**Construction of Temporary Wastewater treatment plant in Upper Orewa to serve the Milldale development**

## Milldale Wastewater Treatment Plant – Response to Watercare Services Ltd feedback to the Milldale Fast-track application.

### Technical Note – Milldale Wastewater Treatment RO Reject Discharge

**Subject Milldale Fast-Track application number: BUN60446761 & FTAA-2503-1038 Wainui Road, Milldale, Upper Orewa, Review of further information provided.**

Figure 1 Mass balance of treatment plant loads detailing RO reject to sewer

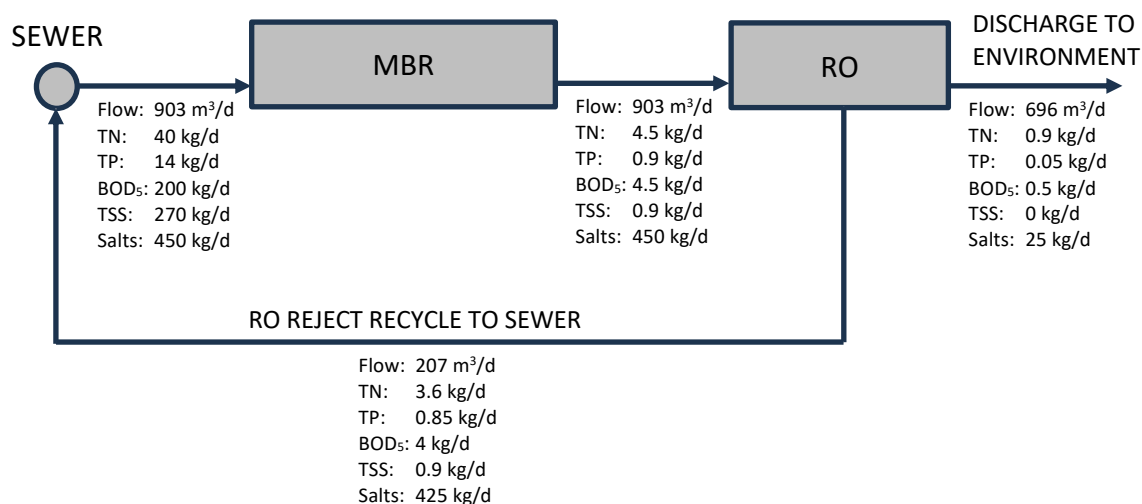
- October memo: 378 m<sup>3</sup>/day
- Apex mass balance: 900 m<sup>3</sup>/day

While WSL acknowledges the need to design for RO/membrane downtime (for cleans), we require a clear definition of min/average/max flows to assess localized impacts of reintroducing the RO reject. While the average RO return flow may appear acceptable, there is a risk that overnight peaks could exceed recommended limits for chloride and sulfate ions. As such, further discussion may be needed to determine the most appropriate method for managing and returning these flows.

- An additional dry weather flow of approximately 207m<sup>3</sup>/day beyond the agreed dry weather flow of 696m<sup>3</sup>/day (29m<sup>3</sup>/hr) is abstracted from the sewer main and treated to compensate for the hydraulic load of the RO reject flow discharged back to the sewer.
- Around 60 – 70% of the nutrient load (TN and TP) and more than 90% of the organic load (BOD<sub>5</sub>) and suspended solids is removed from this additional flow via treatment before returning to the sewer as RO reject.
- The total salt load removed from the sewer is slightly reduced before being returned to the sewer.

This operational philosophy ensures that there is no net negative hydraulic impact on the Watercare transmission network or treatment plant, and a net positive impact of the proposed discharge on Watercare's treatment plant capacity.

The salt loading on the Watercare treatment plant from the RO reject would be the same (actually very slightly better) than if the abstracted sewage was permitted to flow past without passing through the RO. There would however be a net reduction of approximately 2kg/day Phosphorus, 5kg/day Nitrogen, 36 kg/day of BOD<sub>5</sub>, and 60 kg/day of Suspended Solids load on the Watercare treatment plant from abstraction, treatment, and return of the RO reject flow to the network.
